ADDENDUM TO
DRAFT INDIVIDUAL ENVIRONMENTAL REPORT
WEST BANK AND VICINITY
HERO CANAL LEVEE AND EASTERN TIE-IN
PLAQUEMINES PARISH, LOUISIANA
IER #13

OCTOBER 2009

Figure 1. IER #13 Alignment Contract Numbers and Proposed Pump Station Locations

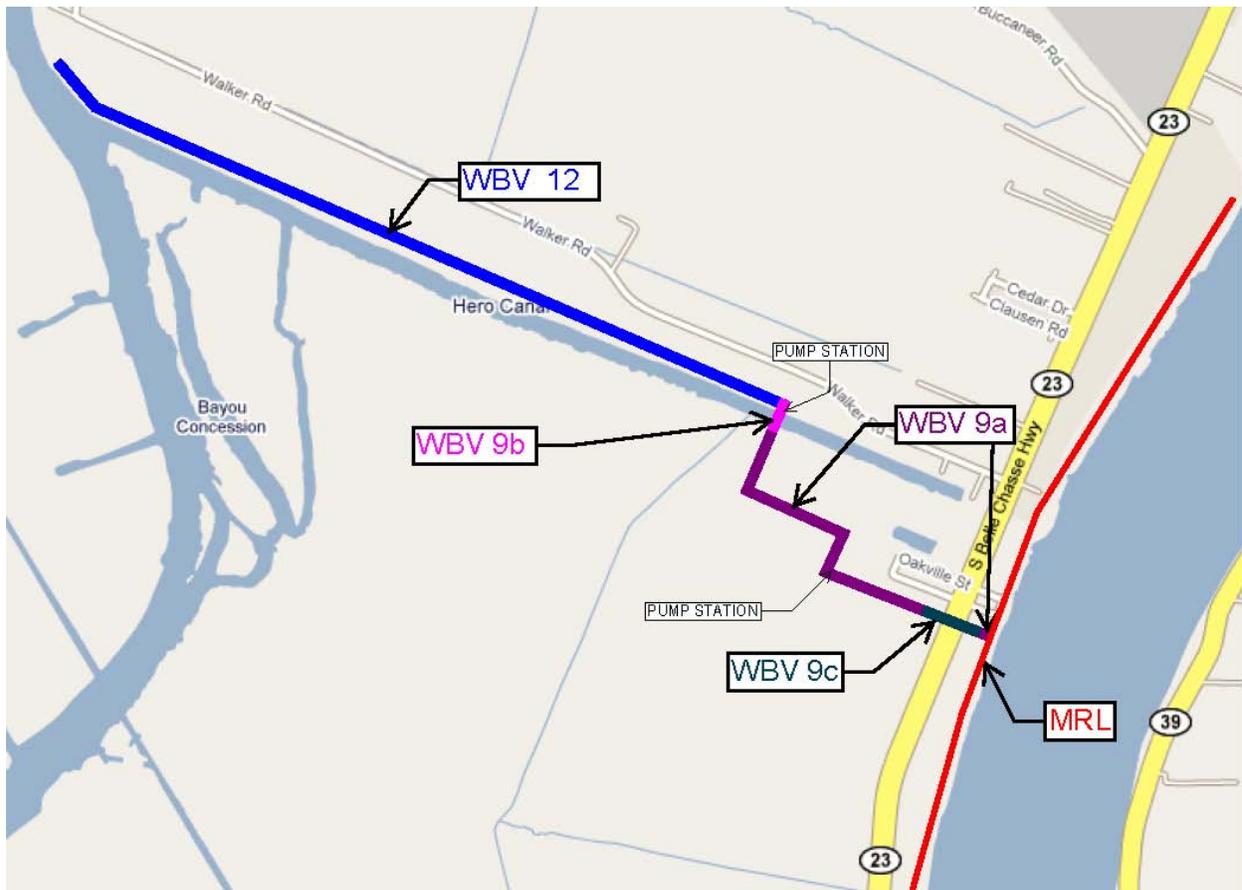
Modifications to the proposed actions for WBV 12, WBV 9a, 9b, and 9c are detailed here. Section 4 provides additional discussion concerning the proposed action for WBV 9c. The remainder of the proposed action alignment, except for the stated modifications, remains as described in the draft IER #13.

- Proposed changes to the project footprint have been made to allow for additional temporary work areas, staging, turnaround, and transportation of project materials. Appendix D details the additional right-of-way (ROW) required. The additional proposed work areas, staging turnarounds, etc would have minimal impacts to the human environment

- The outflow from the proposed 150 cubic feet per second (cfs) pump station in Oakville would be directed to the flood side of the levee system instead of south into the Ollie Drainage Canal as discussed in the draft IER #13 document, Section 2.3. This pump would be primarily utilized during a tropical storm event and for routine maintenance. Day to day stormwater flows would still be directed through an approximately 120 cfs 4ft x 4ft box culvert drainage structure to the Ollie Drainage Canal.

Figure 2. Swing Gates

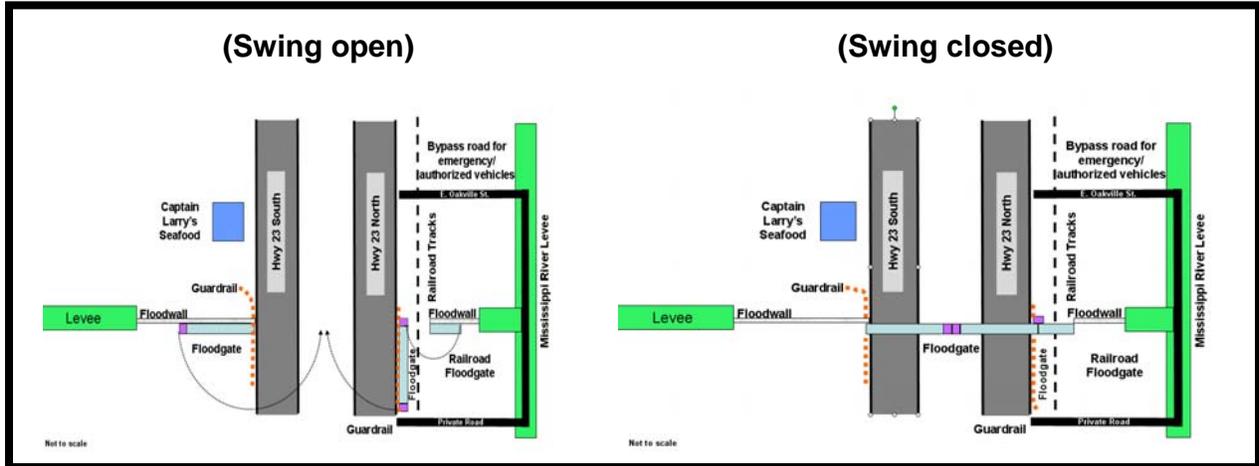
- Redesign of the proposed Hwy 23 crossing provides for wider gates and out of sight storage of the gates to the greatest extent possible. To cross Hwy 23, two approximately 55 ft wide steel swing gates would be constructed to match the adjacent wall at El.14 with the northbound gate storing parallel to Hwy 23 and the southbound gate storing parallel to the floodwall on the western side of Hwy 23 (Figure 2). Mechanical operation of the northbound swing gate would enable closure in high winds. This option allows more flexibility in the timing of closing down lanes of traffic during emergency evacuation situations. Approximately 175 LF of guardrail would parallel the Hwy 23 southbound side of the Hwy along the outside side of the shoulder beginning approximately 80 ft north of the alignment in Captain Larry's parking lot and terminating approximately 95 ft south of the proposed alignment. Approximately 200 LF of guardrail would parallel the Hwy 23 northbound side

of the Hwy along the outside of the shoulder beginning approximately 150 ft south of the alignment and terminating approximately 50 ft north of the alignment. A removable center column to which the swing gates would latch and close excludes the need for guardrail in the Hwy 23 median. To cross the railroad tracks that are located parallel to the eastern side of Hwy 23, a swing gate built to El. 14 would be constructed. The railroad swing gate would store parallel to the wall on the eastern side of the railroad tracks. Figure 1 shows the configuration of the Hwy gates and railroad gates in open and closed position.

Figure 9. Proposed Interior Drainage in the Vicinity of Oakville

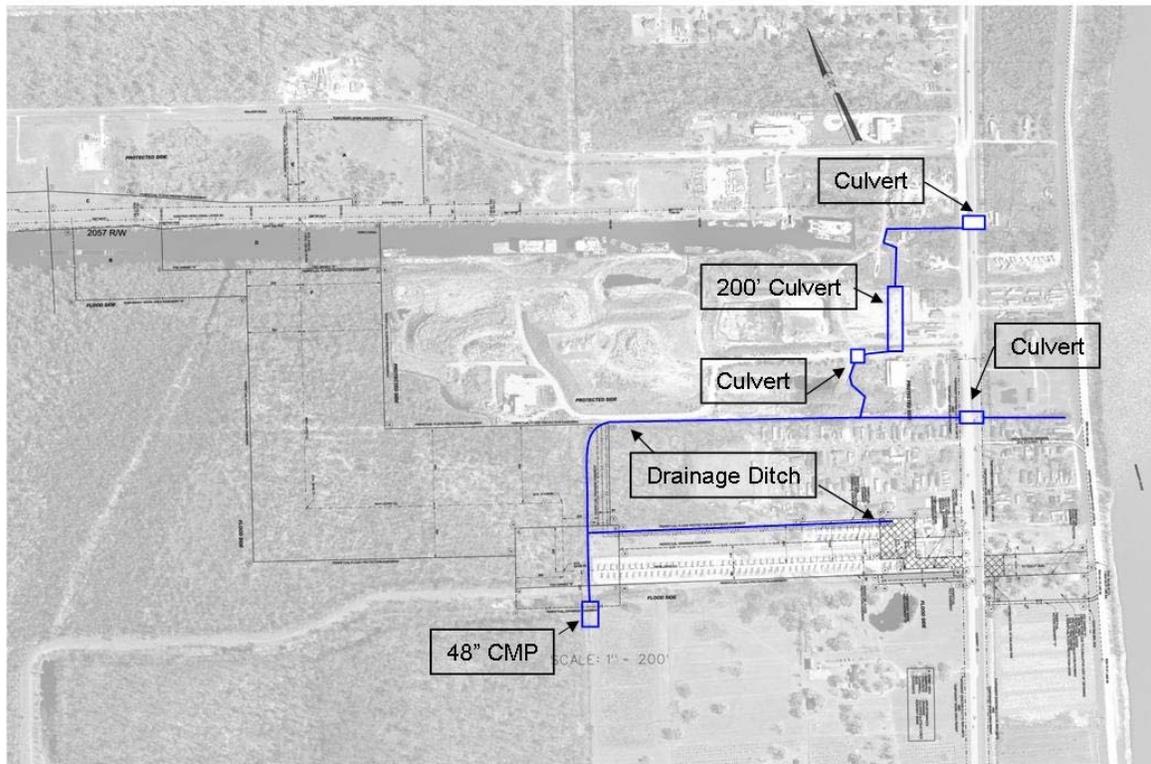
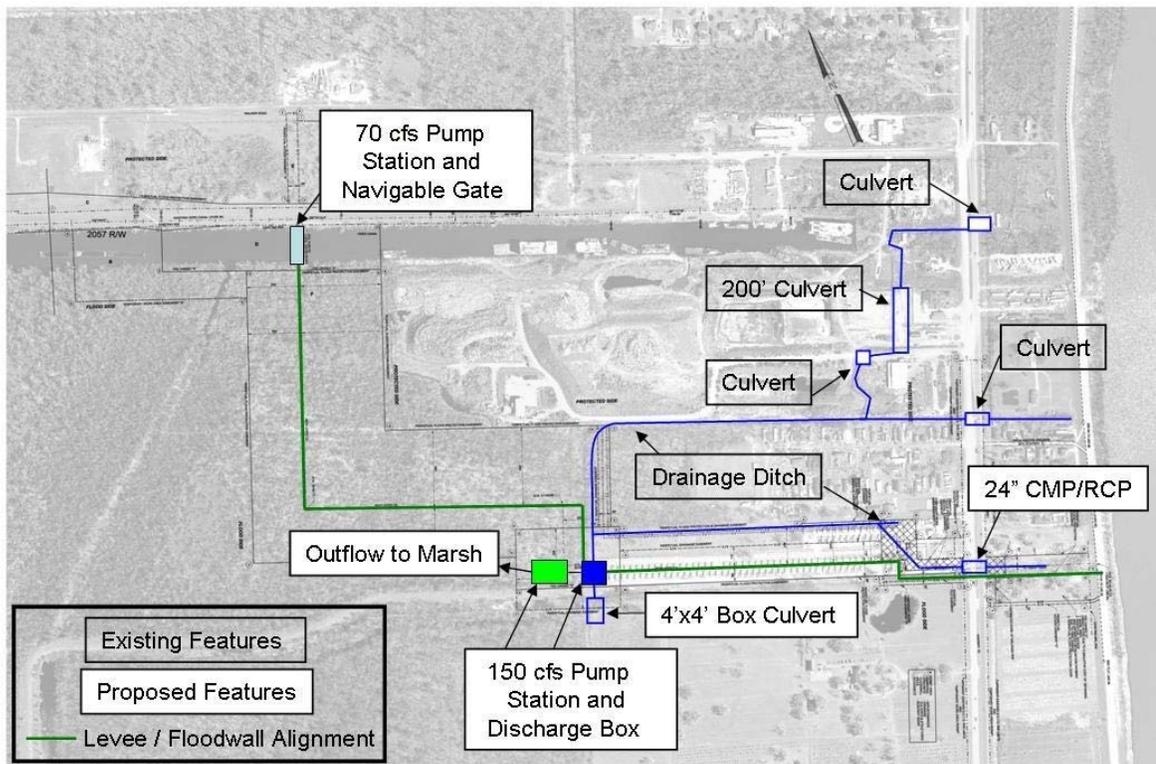
As stated previously, the proposed Hwy 23 floodgate would have no impact on the drainage in the interior of Oakville or the area south of the floodgate. Additionally, gravity drainage into Ollie Canal would only occur during non-tropical rainfall events. The proposed 150 cfs pump station would direct rainwater to the floodside of the system during tropical events, thus lessening the volume of water currently flowing to Ollie Canal during a tropical event. There are three key changes to the drainage situation that were analyzed by industry standard hydraulic analysis methods that determine the effects of the proposed action. The three key changes are listed and explained below:

- **Runoff in the Interior of Oakville:** An analysis of the drainage area that would be captured by the proposed levee and floodgate shows that up to 5 cubic feet per second (cfs) of flow would be added to the interior runoff discharge in Oakville (Figure 8). This is a result of redirecting rain water accumulated between Hwy 23 and the Mississippi River Levee to the outfall drainage structure located in the southeast corner of the project area. This is an insignificant increase when compared to the peak internal drainage flow of about 240 cfs from a 10 percent annual chance of exceedence rain event.

- **Increase in Gravity Drain Flow (effects on the interior of Oakville):** The existing 48 inch corrugated metal pipe located on the southern side of the project area can carry about 95 cfs for the design storm. The proposed 4 ft x 4 ft box culvert can carry 120 cfs for the same storm (Figure 9). For the interior of Oakville, this means that no additional ponding would occur as a result of the replaced gravity drain. The peak stage in the Oakville area for the 10 percent annual change of exceedence event would be lowered by less than 1/10 of a foot as a result of this proposed change.

- Increase in Gravity Drain Flow (to Ollie Canal and the Ollie Pump Station): The flow increase through the proposed gravity drain (when compared to the existing pipe) would have a negligible effect on the area exterior of Oakville, which drains through Ollie Canal to the Ollie Pump Station. Although the peak rain water flow through the gravity drain increases by 25 cfs, the Ollie Pump Station is designed to handle a much greater flow, and therefore, the stage in the canal is estimated to only increase a minor 1/100 of a foot. Plaquemines Parish has indicated that the Ollie Canal Pump Station as designed can accommodate up to a 50 percent annual chance of exceedence rain event.

Figure 14. Swing Gate Alternative Diagram

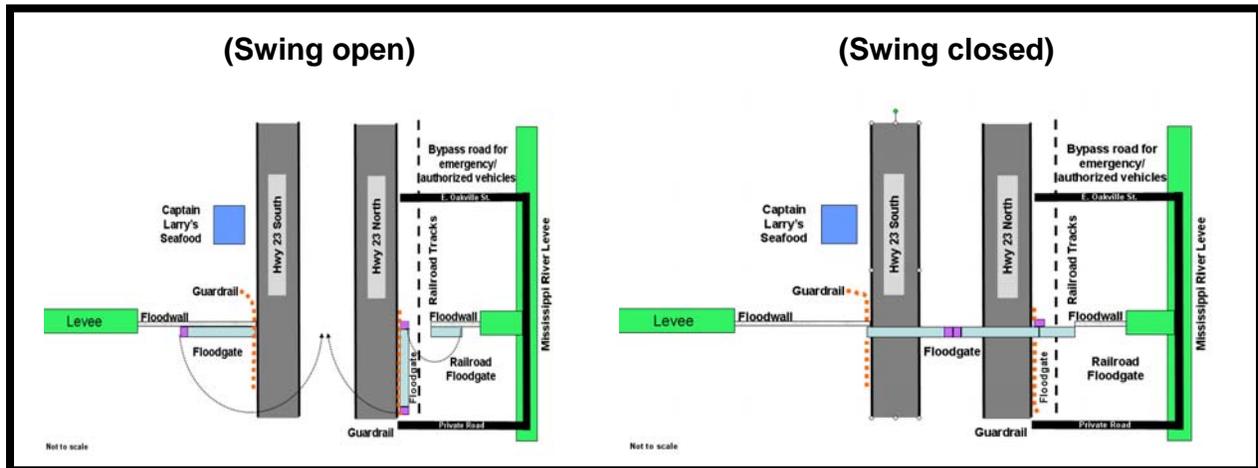
The swing gate alternative would begin at the earthen levee west of Captain Larry's. It would include 450 ft of El. 14 traditional T-wall that would be constructed eastward and terminate 19 feet west of the Hwy 23 southbound travel lanes. A 55 ft swing gate with an attached storage column would swing from the T-wall across the southbound travel lanes and the attached storage column would be secured in a recess within the pile founded slab. Another 55 ft swing gate would swing across the northbound travel lanes from a permanent storage column set back 16 feet from the roadway and attach to that same storage column. A 25 ft swing gate would be

constructed to cross the railroad tracks and tie into 70 ft of traditional T-wall. The T-wall would transition to the WBV 9a earthen levee which would tie into the MRL (Figure 14).

The swing gates would close over a pile founded slab across Hwy 23 to form an effective seal. The gates would be built to a design elevation of El. 14, highway sill at El. 6. The southbound swing gate would be closed manually. The northbound swing gate would be closed with a hydraulic motor or if required, manually, by 2 people in less than four hours. This design allows the flexibility to close the gate within a safe timeframe to allow the only Plaquemines Parish evacuation route to stay open longer and still ensure operator safety as hurricanes approach the area.
